Driver's Seat Squeaks

(Supersedes 06-018, dated May 12, 2006, to update the information marked with the black bars)

Locate the scratch mark made by the seat frame.

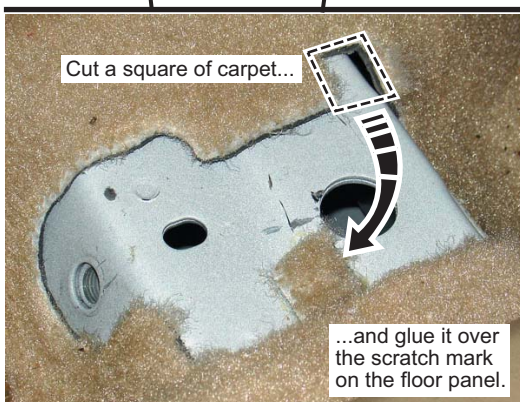
6. Locate the scratch marks made by the seat frame on both sides of the floor panel (right side is shown).

7. Cut two 15mm square pieces of carpet from underneath the driver's seat, and use weatherstrip adhesive to glue them over the marks as shown.
